North ground-brace alignment correction

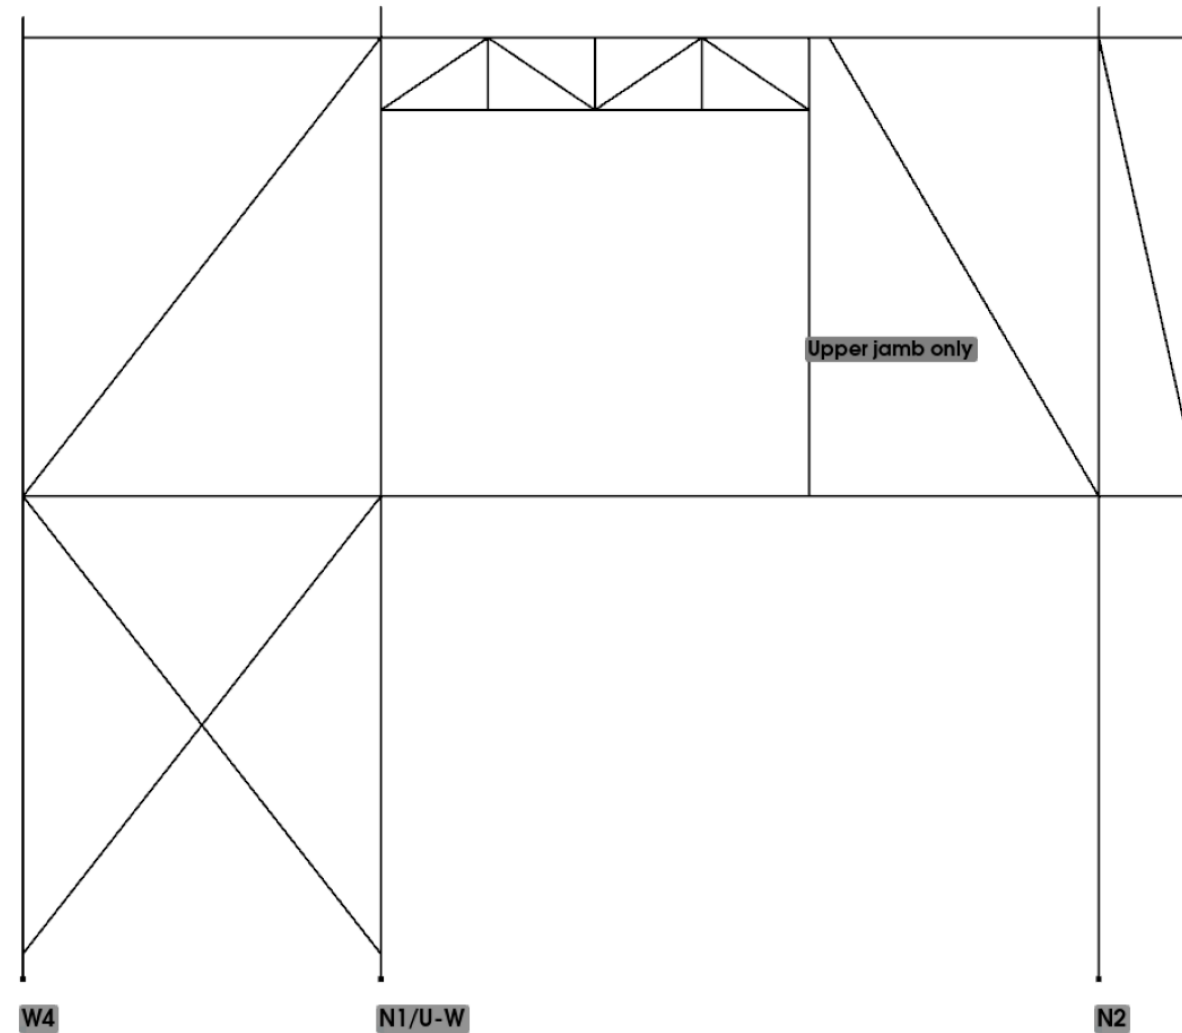
Both X-braces between W4 and N1 / U-W were offset 4 inches north of the column axes. All four brace endpoints now coincide with those axes. The analytical offset links at those four connections are eliminated. Attachment heights remain at 6 inches and 115 inches above datum.

W4 is at north-coordinate 253 inches; N1 is at 252.5 inches. The braces follow the plane between those columns, including that half-inch difference. The TN truss above remains in its existing plane at north-coordinate 249 inches. Its short connections to the posts are separate from this ground-brace correction.

TN Corrected wall elevation

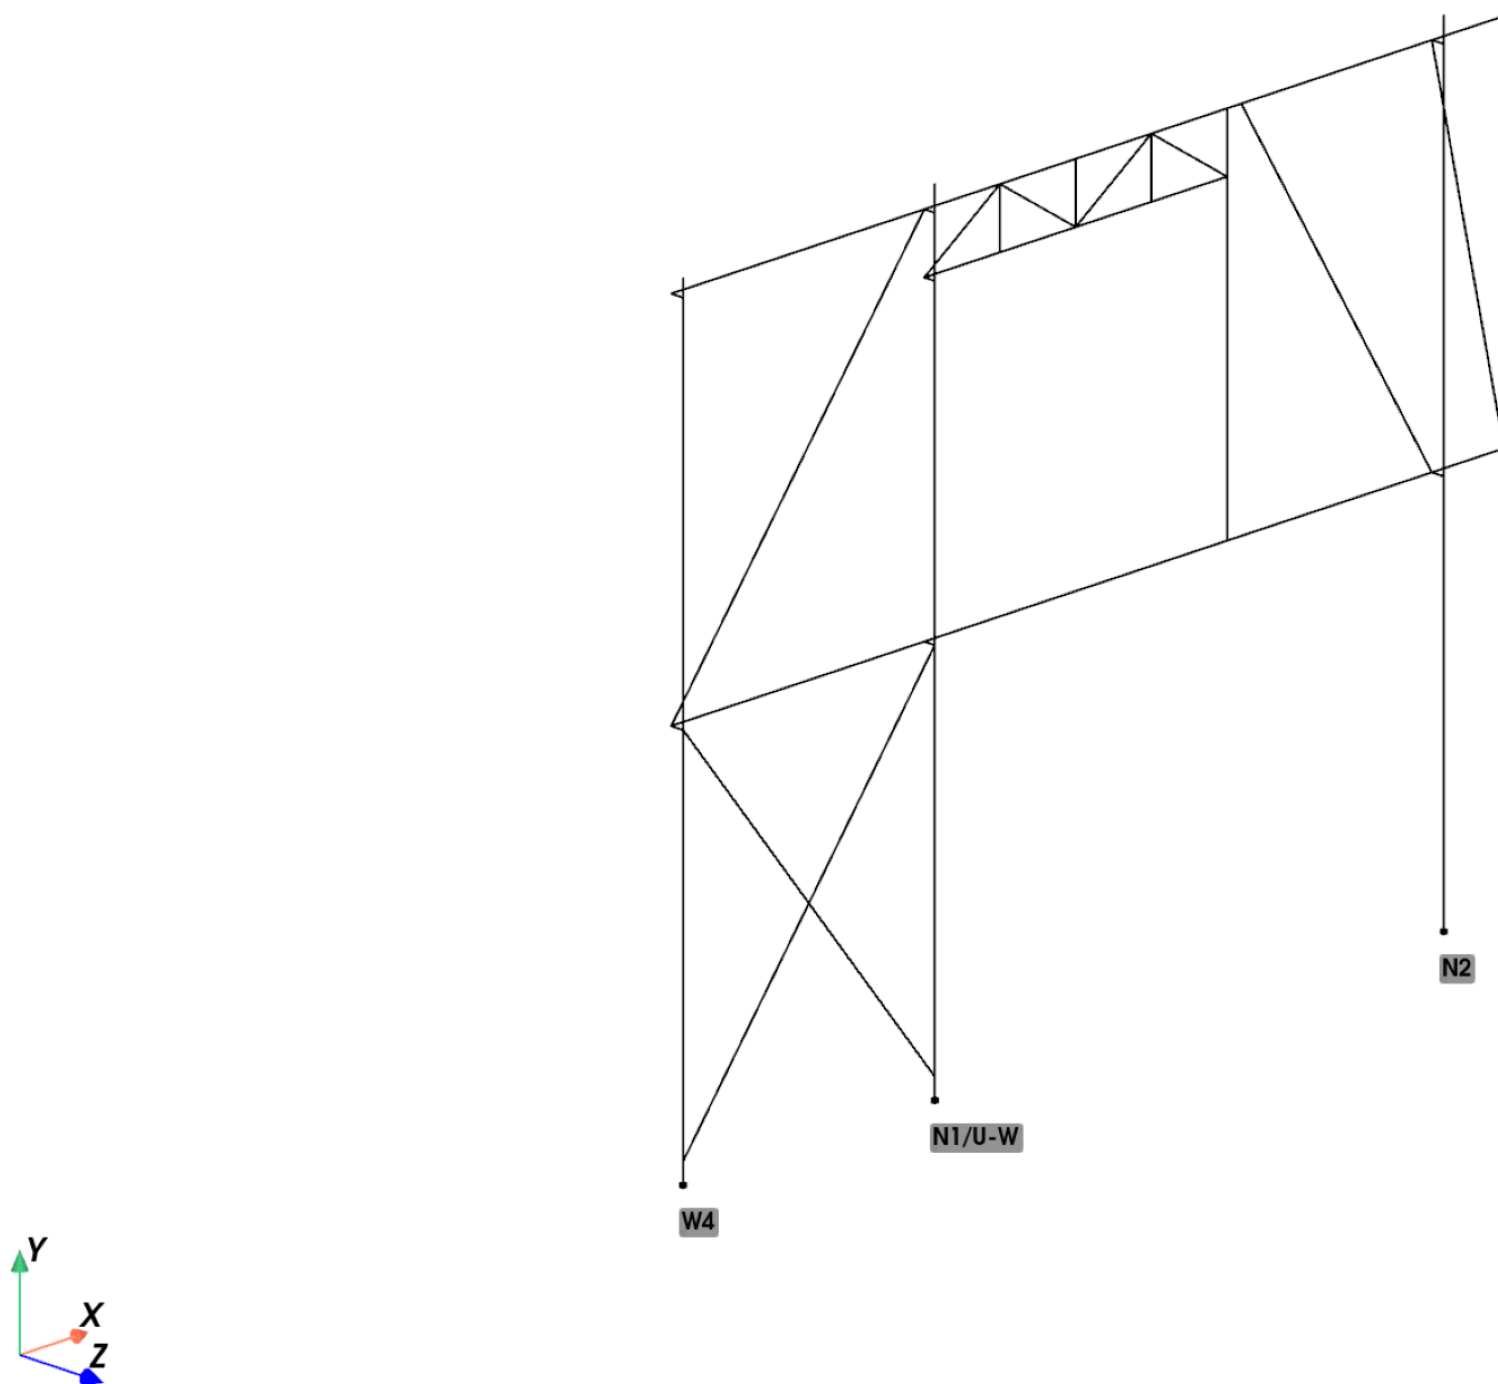
Shared columns replace duplicate truss uprights. Ground-level X bracing retained.
Preliminary fixed-base model; connection and foundation design remains.

NORTH Support path

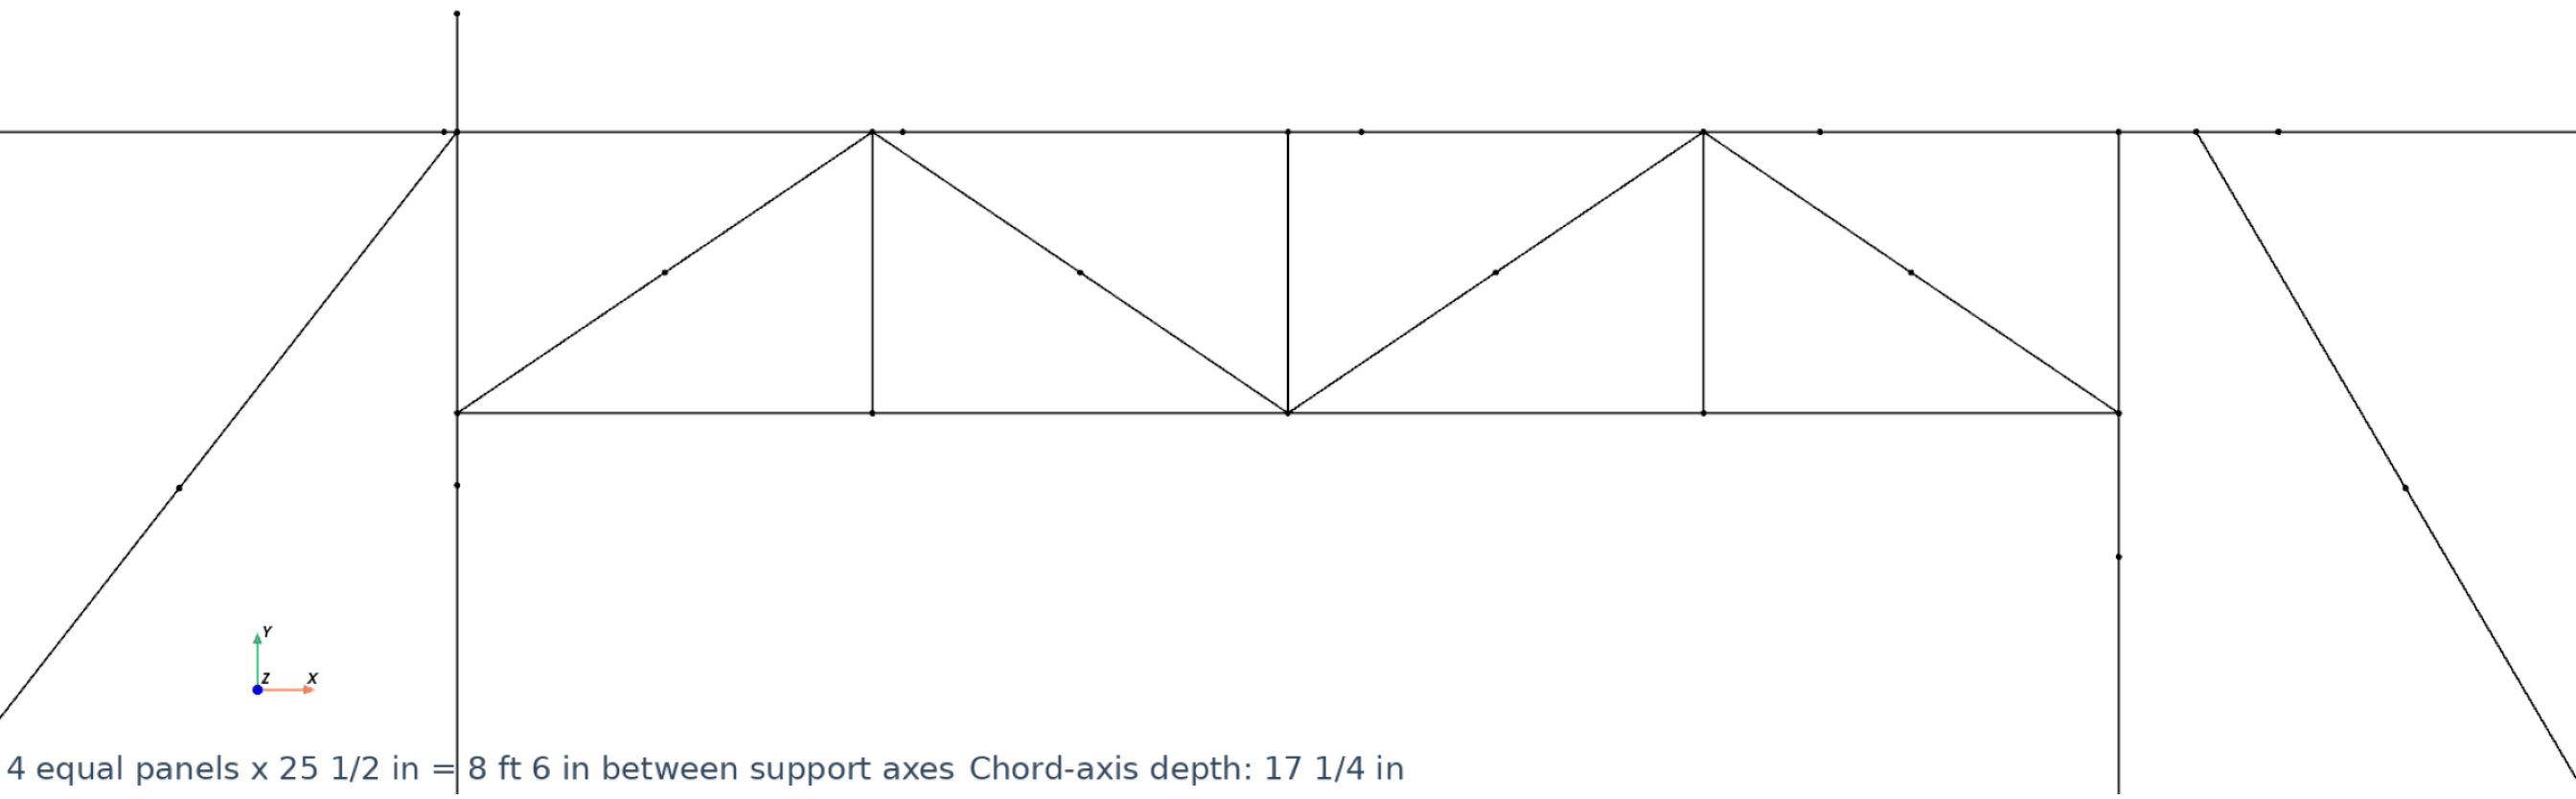
Shared columns replace duplicate truss uprights. Ground-level X bracing retained.
Preliminary fixed-base model; connection and foundation design remains.

TN Corrected over-door mini-truss

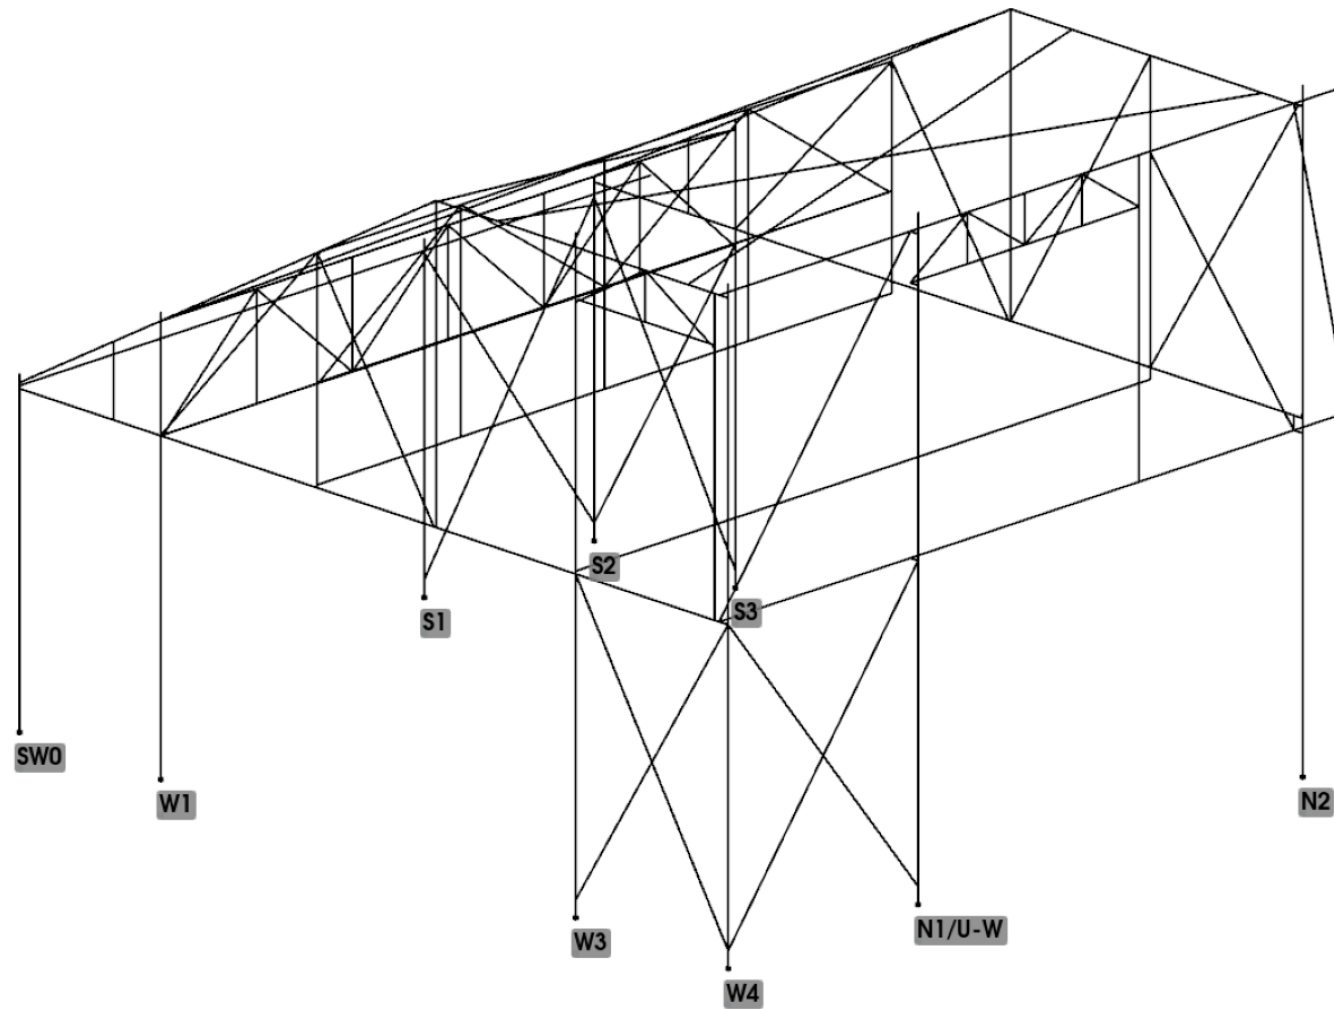
Shared columns replace duplicate truss uprights. Ground-level X bracing retained.
Preliminary fixed-base model; connection and foundation design remains.
